NANTUCKET FIRE DEPARTMENT
131 Pleasant Street
Nantucket, Massachusetts 02554

May 13, 2019

Re: Surfside Crossing 40B development

The Nantucket Fire Department has reviewed the submitted revised plans. The Nantucket Fire Department submits the following as requirements for this project.

Sheet Title:
OVERALL SITE DEVELOPMENT PLAN
"SURFSIDE CROSSING"
A
PROPOSED 40B DEVELOPMENT IN NANTUCKET, MASSACHUSETTS
Prepared For:
SURFSIDE CROSSING, LLC
#3, 5, 7 & 9 SOUTH SHORE ROAD MAP 67 PARCELS 336, 336.7, 336.8 & 336.9

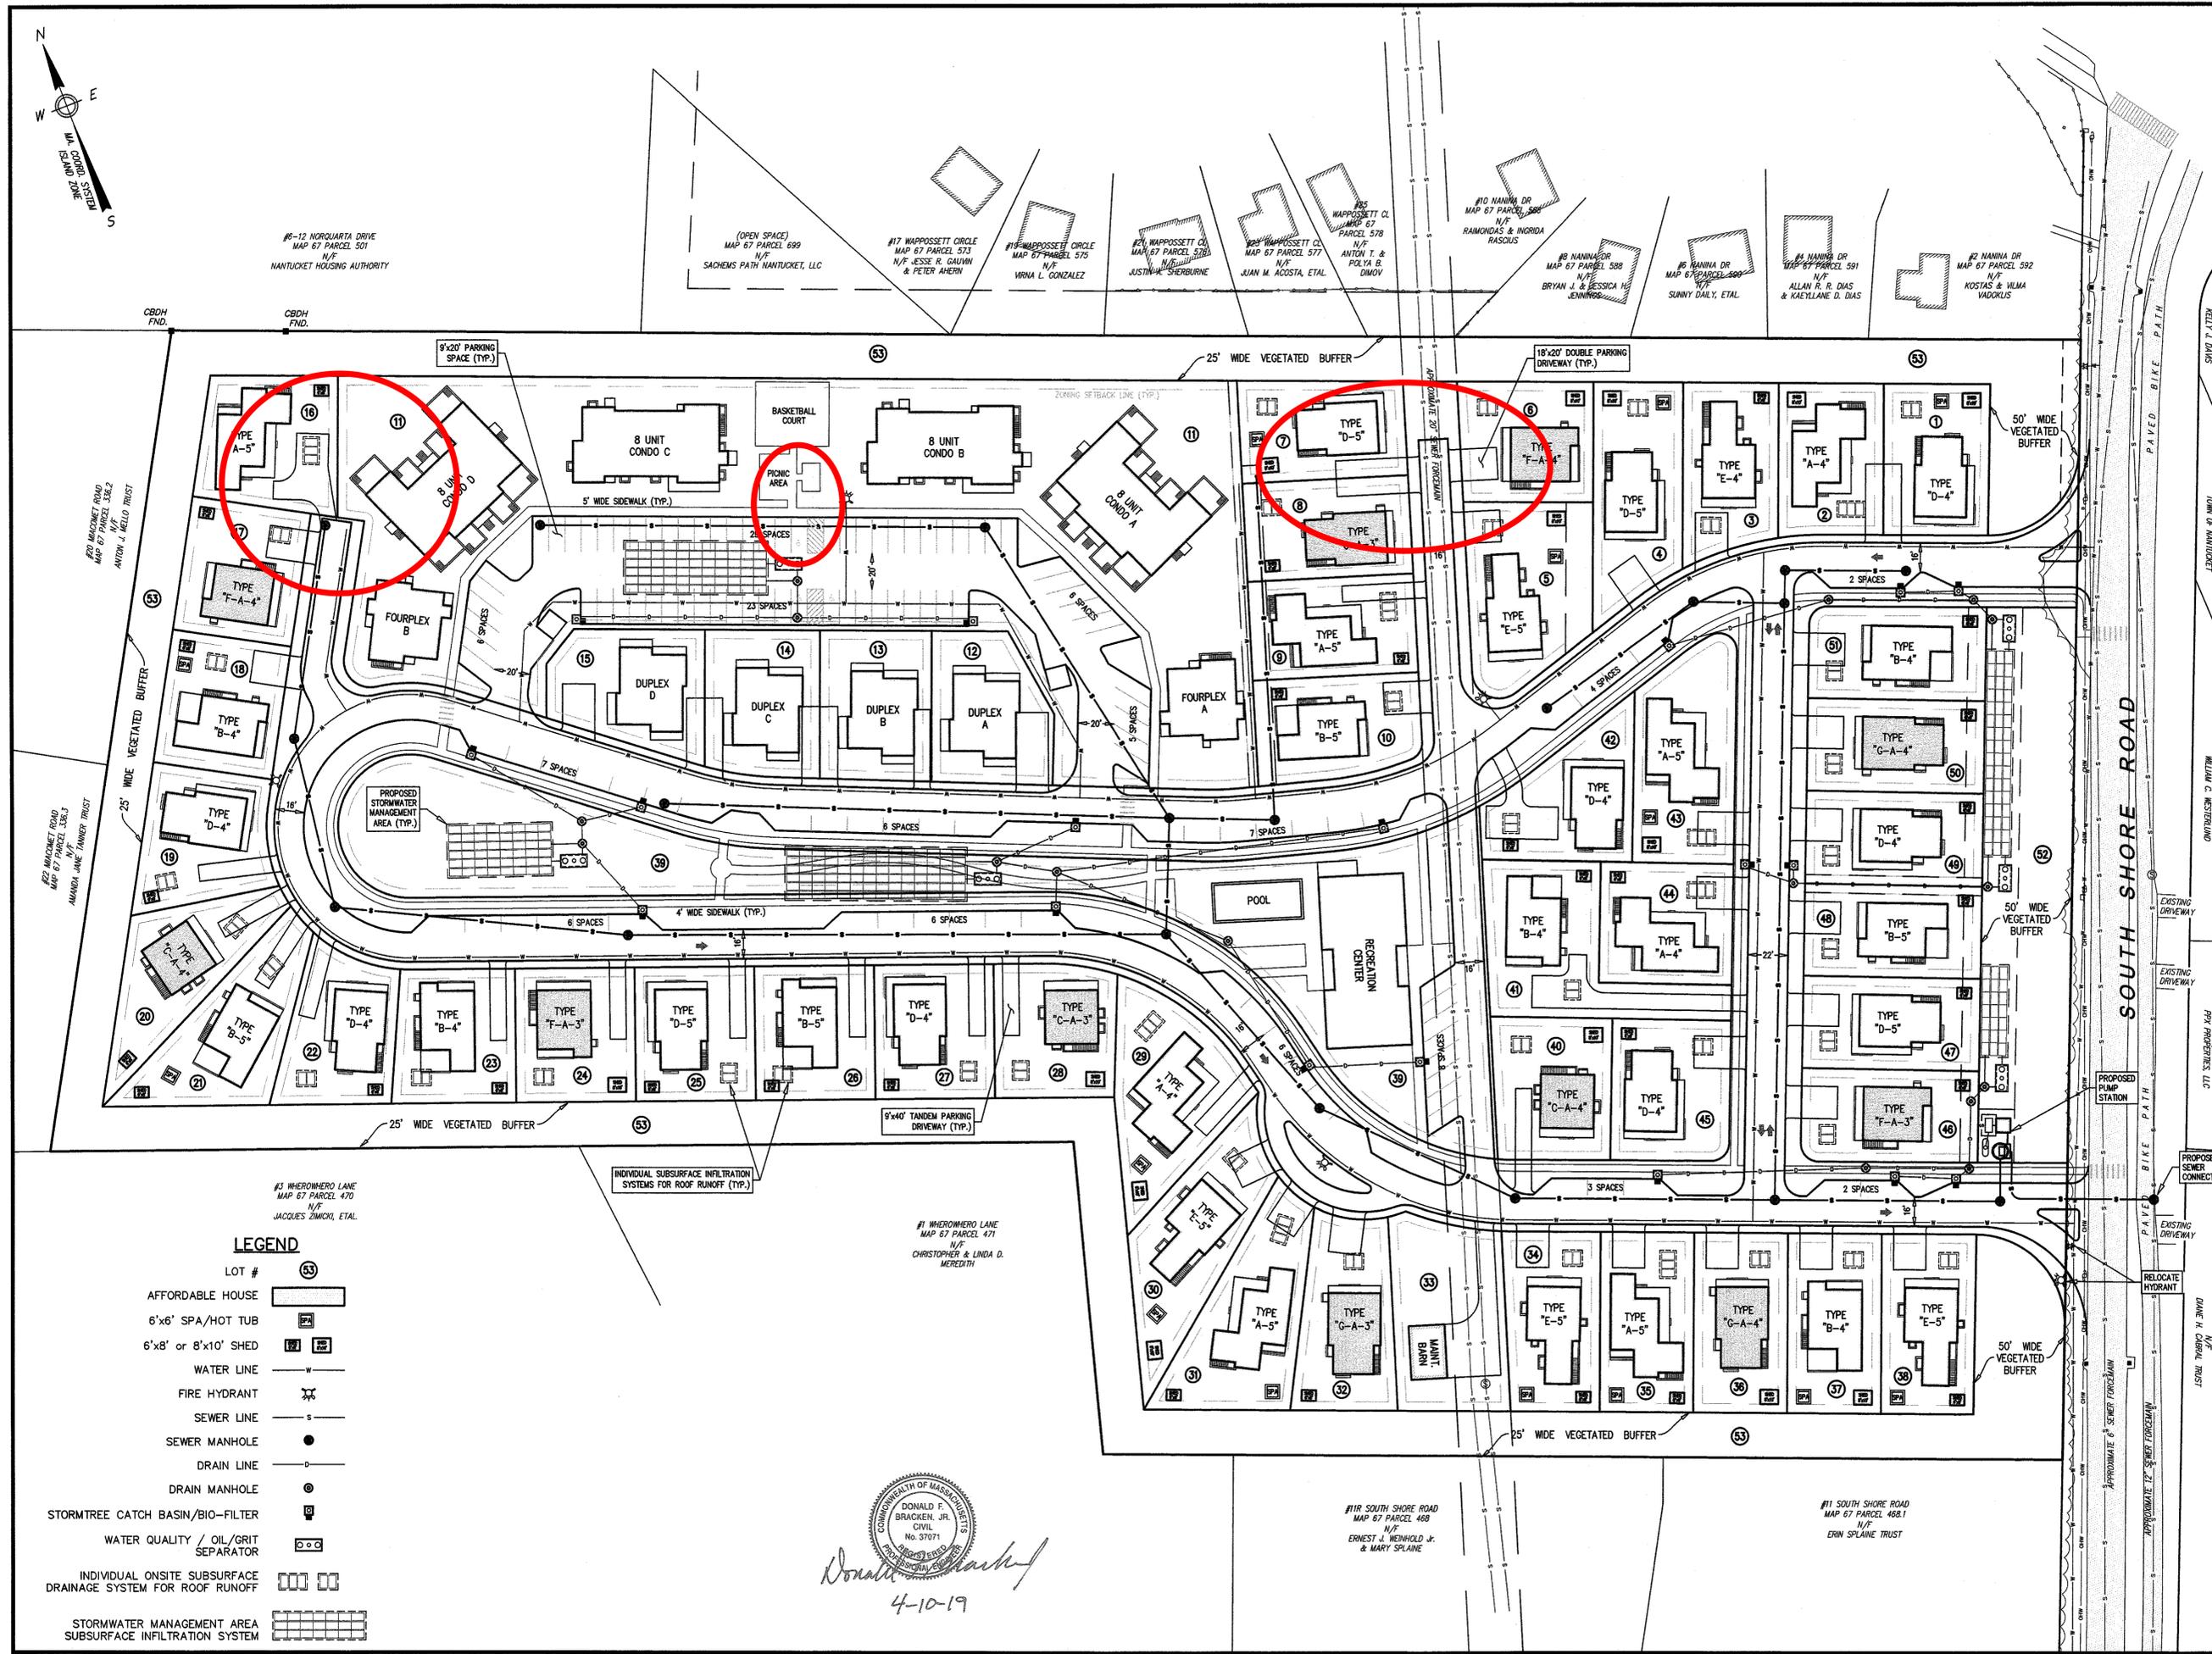
1. Access roads must be 20 feet in width not including parking (527 CMR18.2.3.4.1.1),
 - a. No on street parking allowed that would narrow the roadway below 20 feet on two way sections
 - b. No on street parking on one-way sections where width will be reduced below 13 feet.
 - c. Several roadways on the plan show widths less than 20 feet for one-way sections. This will be allowed with posted and enforced no parking in these sections
 - d. A section of roadway that is two-way is 22 feet and must be posted and enforced with no parking.
 - e. Modeling is not given in drawings to assure the fire departments apparatus can access development.
 - f. Two of the roads have no provisions for turning around. (527 CMR 18.2.3.4.4) "Dead-end access roads in excess of 150 feet in length shall be provided with approved provisions for fire apparatus to turn around."

2. Trees and vegetation must be maintained and not allowed to grow to block access for emergency vehicles. This would include vertical growth of tree. (527 CMR 18.2.3.4.1.2)
 - a. All roadways shall have a vertical clearance of not less than 13 feet 6 inches.
 - b. Vegetation must not reduce the road width below required in above section

3. The access to the apartment buildings is again a concern.
 - a. There is no secondary access for the apartment buildings; a single two-way drive limits access.
 - b. The Fire Department would have difficulty positioning multiple emergency vehicles in the event of an emergency.
 - c. The rear of all but one Condo are inaccessible to fire apparatus.
 - d. Parking lot spaces that are perpendicular to the travel lanes must be 22 feet in length to avoid overhanging vehicles into the roadway. In the plans submitted parking lengths are not shown.
 - e. No defined clear access for emergency services to Condos. Emergency personnel would have to work between parked cars to access majority of the Condo units.

5. Hydrant lay out needs to be defined and installed before construction begins.
